ANDALEX RESOURCES, INC.

WILDCAT LOADOUT
SEDIMENT POND "F"
EXISTING/MODIFIED

REVION NUMBER: 1	SCALE: AS SHOWN
DATE: MAY 2007	PLATE 3C

PLAN VIEW
SCALE: 1" = 50'

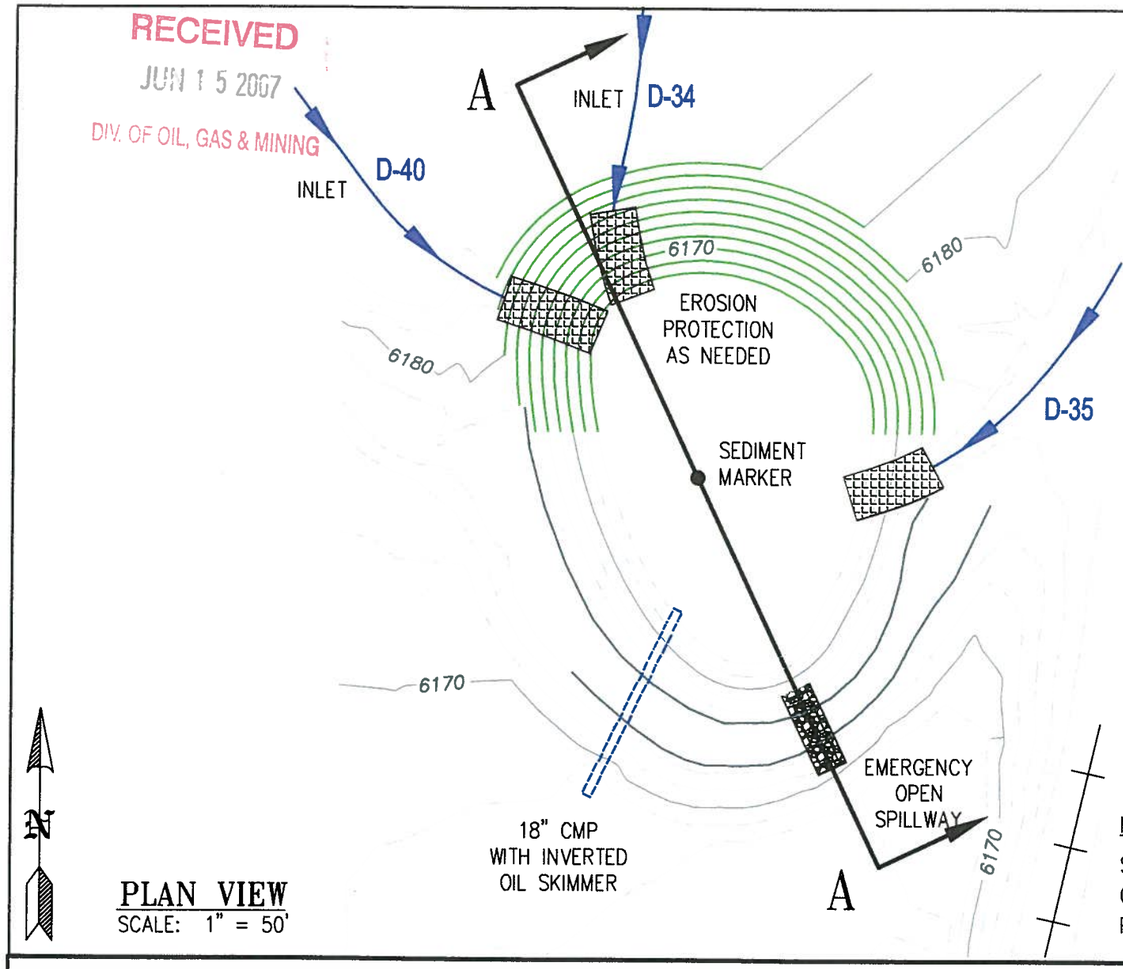
SEDIMENT POND WILL BE EXTENDED TO THE NORTH.
GREEN CONTOURS REPRESENT PROPOSED CONSTRUCTION.
PRINCIPAL SPILLWAY WILL BE CHANGED FROM A 12" CMP TO A 18" CMP.
